HISTORIC PRESERVATION BOARD

HISTORIC PRESERVATION BOARD MEETING

**PUBLIC HEARING
754 CONGRESS STREET**

TO: Chair Sheridan and Members of the Historic Preservation Board
FROM: Deb Andrews, Historic Preservation Program Manager
DATE: February 14, 2020
RE: February 19, 2020 **PUBLIC HEARING - Final Review of Proposed
Hotel Construction**

Owner	
Prepared For:	
Consultant:	
Architect:	ARCHETYPE ARCHITECTS 48 Union Wharf Portland, Maine 04101 (207) 772-6022 Fax (207) 772-4056
Project:	754 CONGRESS 754 Congress Street Portland, Maine
Revisions:	
Date:	3 JAN 2020
File:	As indicated
BUILDING ELEVATIONS	
A2.01

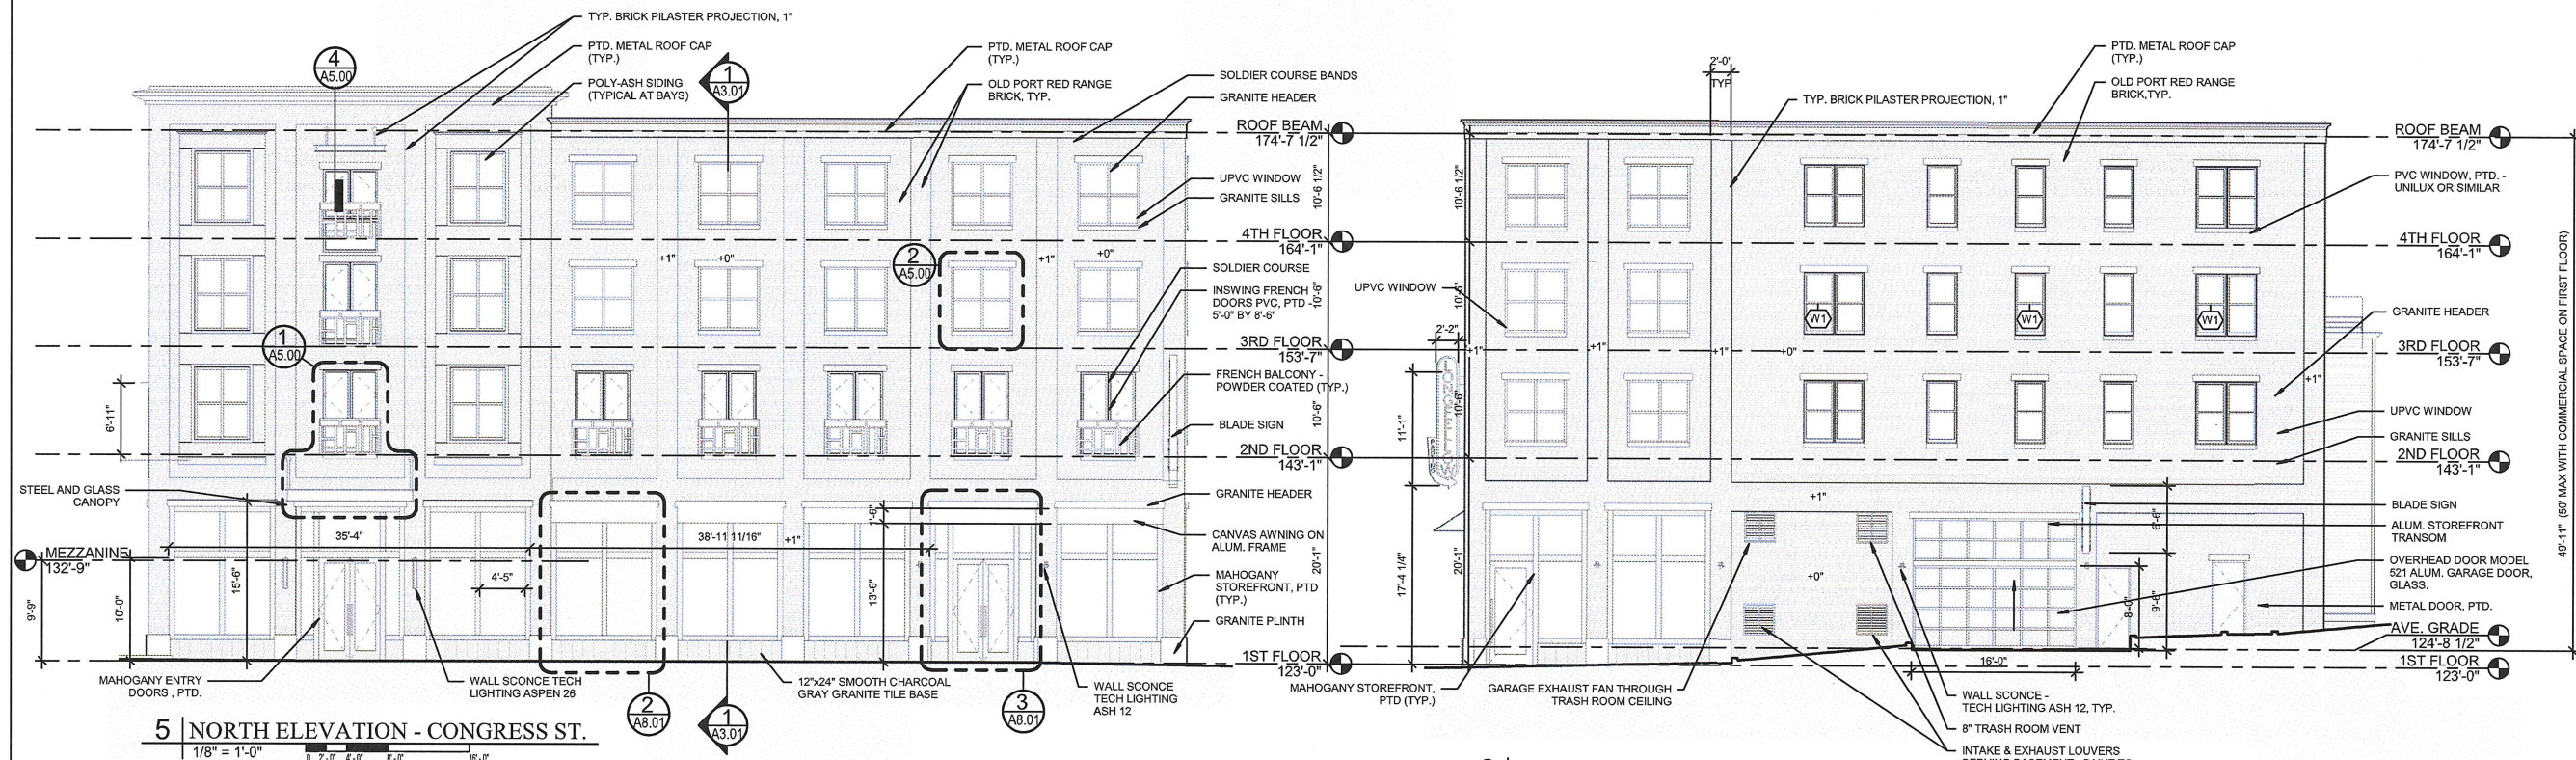
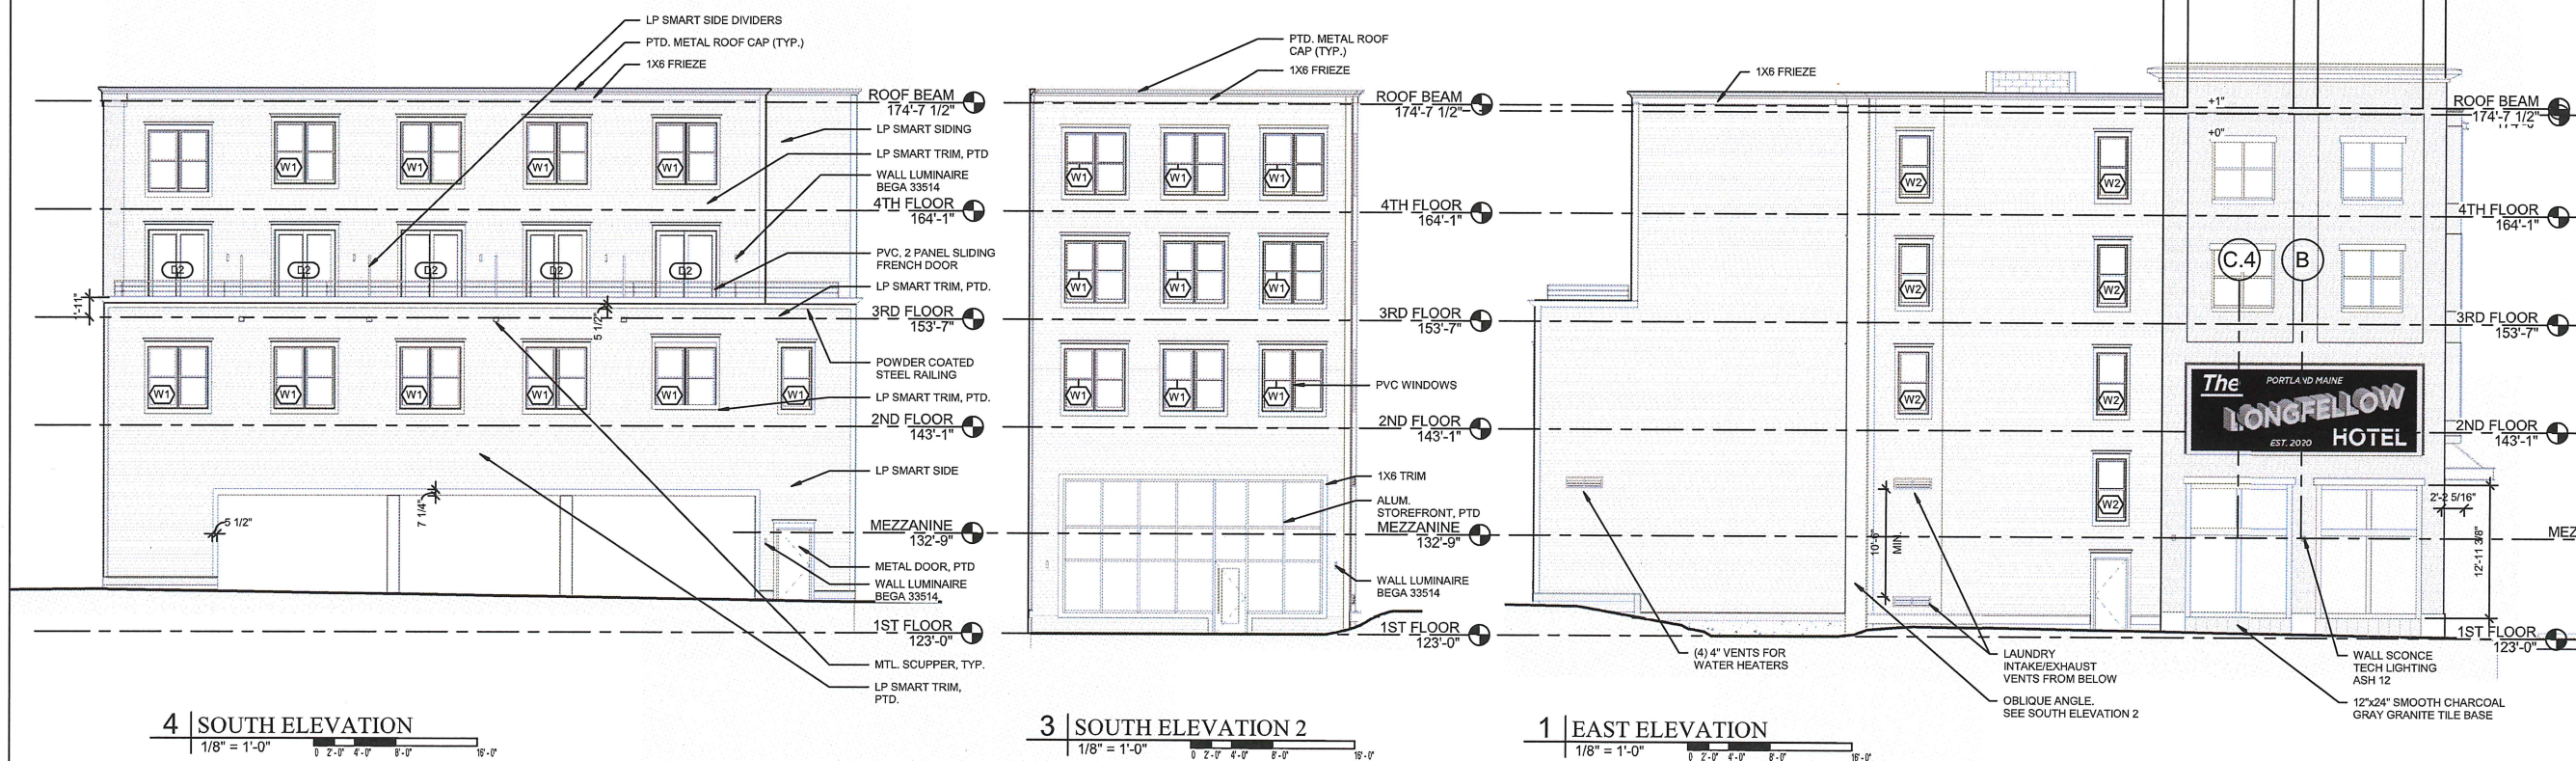
- On the Neal Street elevation, the height of the garage door opening has been increased. The height of the opening now aligns with that of the storefront windows. The added height is achieved through the introduction of a “transom” over the garage door.

- The ground floor of the Neal Street elevation now also shows four proposed vents within one of the inset brick panels and an additional door within another inset panel. These added elements add a bit more complexity to this portion of the Neal Street elevation than shown in the previous drawings.

- On the south (rear) elevation's two-story projecting section, the clapboard exterior returns onto the Neal Street face of this section
- While not an exterior design change, the mezzanine level has been pulled back from the storefront to reduce its visibility and visual impact from the street.

6 | JULIETTE BALCONY DETAIL
1 1/2" = 1'-0"

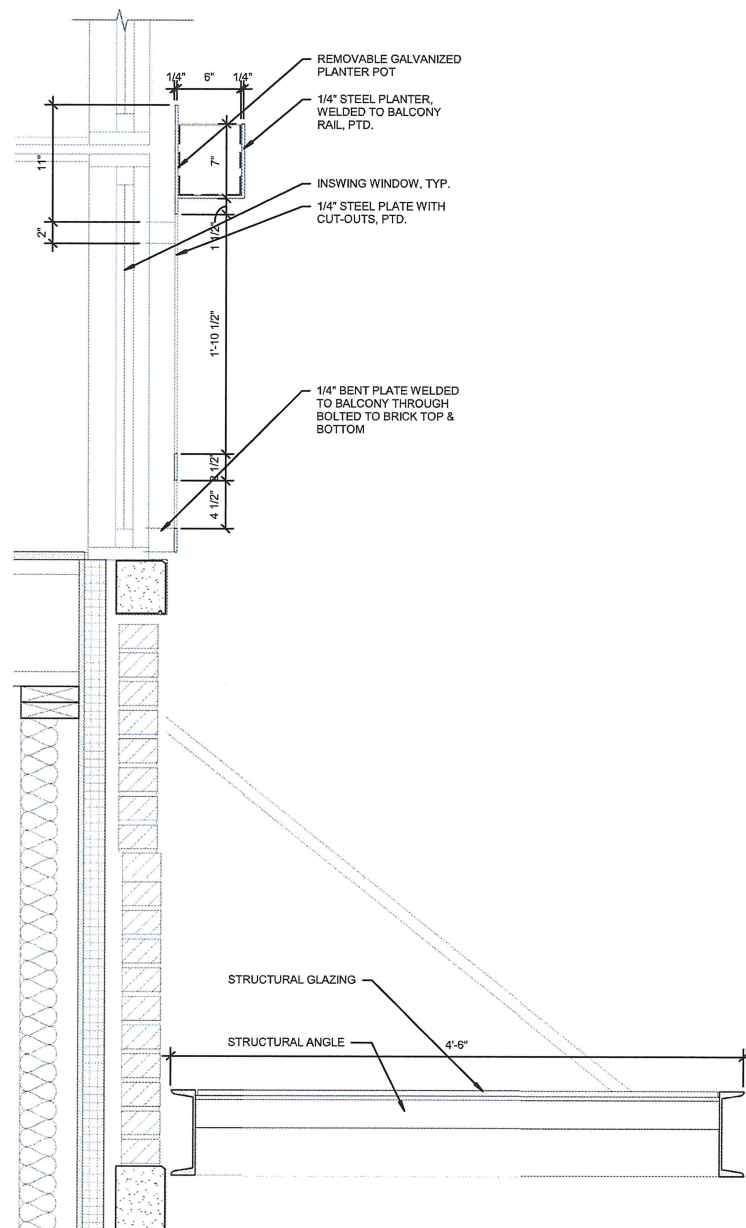
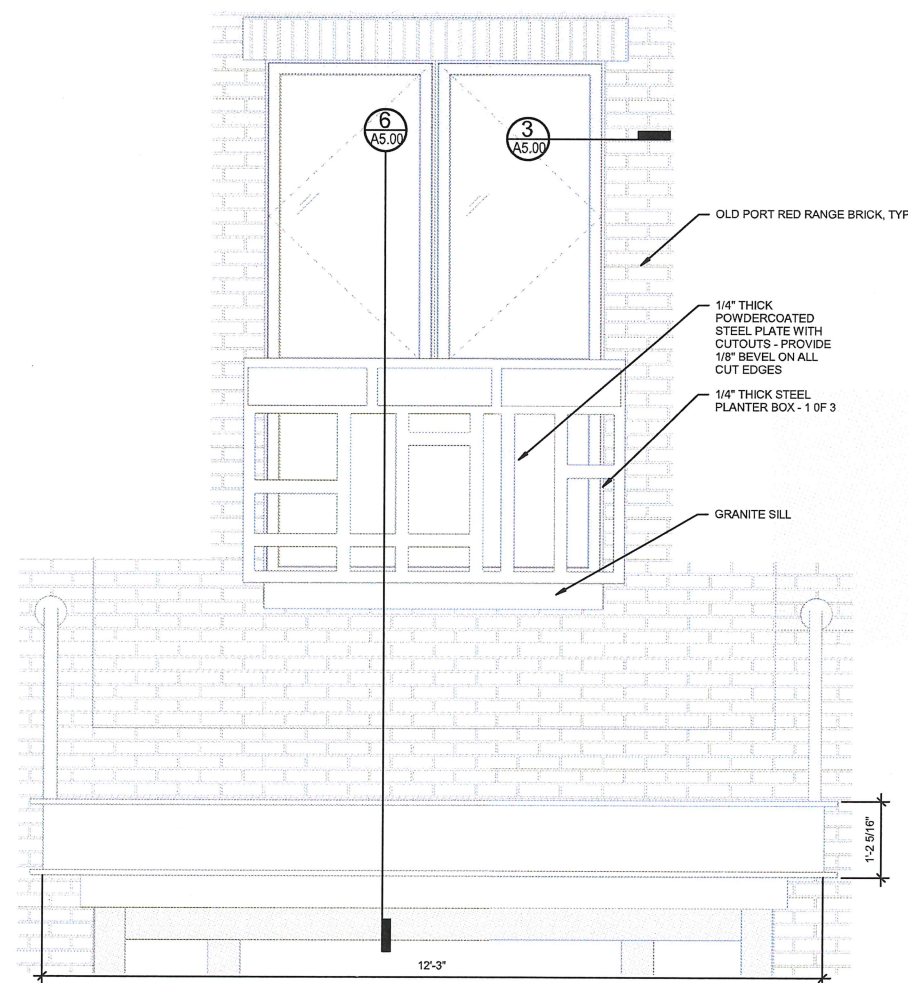
- question raised re: visual impact of the mezzanine level as viewed from the street
- additional details requested for proposed railings in front of the Juliet balconies
- adjustments recommended for material returns at the southwest corner of building
- fencing suggested at rear property line to shield view of cars
- clarification requested re: reveal of the punched openings
- final submission to include additional details, dimensions, specifications.
- mechanicals to be shown on final submission
